UNITED STATES PATENT AND TRADEMARK OFFICE

APPLICATION NO.	FILING DATE	FIRST NAMED INVENTOR	ATTORNEY DOCKET NO.	CONFIRMATION NO.
10/632,449	07/31/2003	Lynn Bich-Quy Le	1229.0001	3797

Office Action Summary

DETAILED ACTION

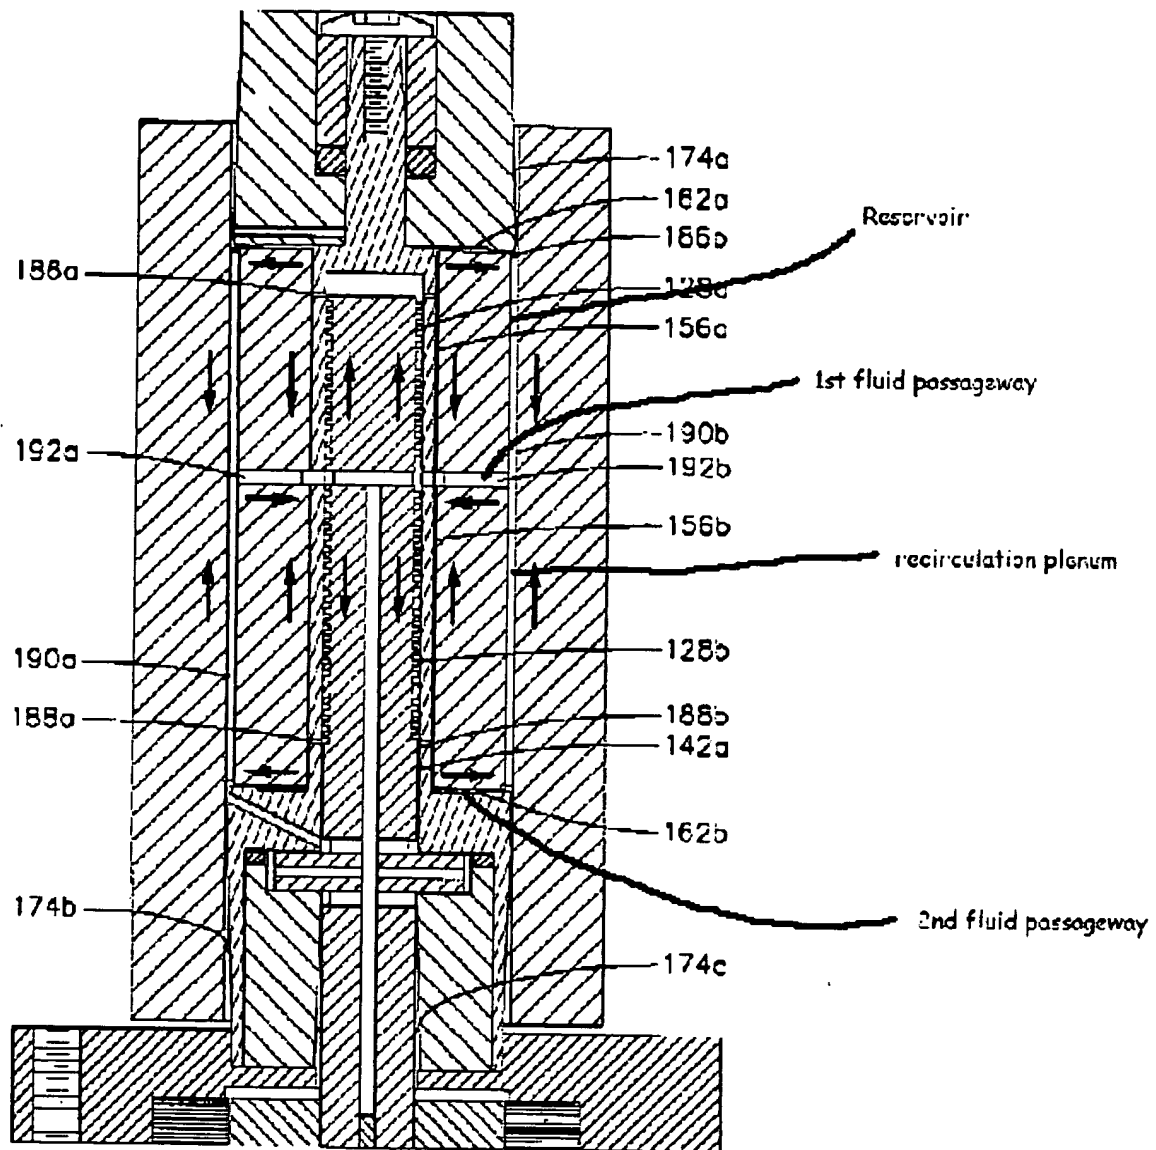
6. Claims 15, 20, 34-36 and 39, as best understood, are rejected under 35 U.S.C. 102(b) as being anticipated by Titcomb (US Patent 6,315,452).

Titcomb discloses a hydrodynamic bearing assembly for use in combination with a spindle motor of a disc drive device comprising:

-a journal (generally 156) defined between an inner component (112) and an outer component (146), which are positioned for relative rotation.

-a fluid recirculation passageway including a first fluid passageway (192) defined within the outer component and in fluid communication with a second fluid passageway (162b), the second fluid passageway defined between the outer component and a radial member (158b) extending radially from the inner component, the first and second passageways in fluid communication with the journal at separate locations,

-a shield (160) affixed to the stationary component, defining a reservoir (190) with the outer component, and a recirculation plenum is defined by a junction joining the reservoir, the first fluid passageway and the second fluid passageway, and means for sealing the reservoir.

Regarding claim 34, the device comprises means for creating an asymmetric pressure gradient within the fluid recirculation passageway (see fig 7), circulating fluid and purging air in the fluid, wherein the fluid substantially circulates about the journal, the first fluid passageway and the second fluid passageway (see figure 3).

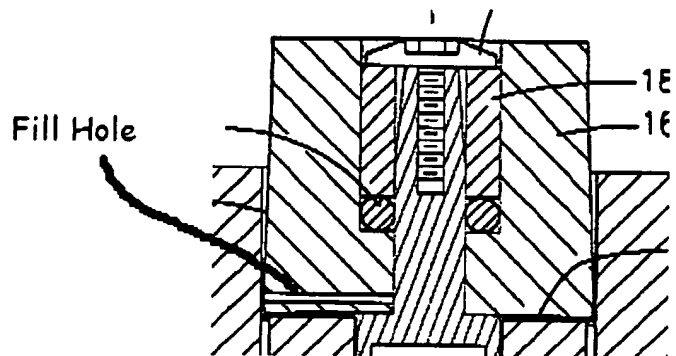
Regarding claim 19, a fill hole (see fig below) is defined within the shield, wherein a meniscus is positioned between the fill hole and the fluid in the reservoir, the fill hole making an angle with the surface of the shield.
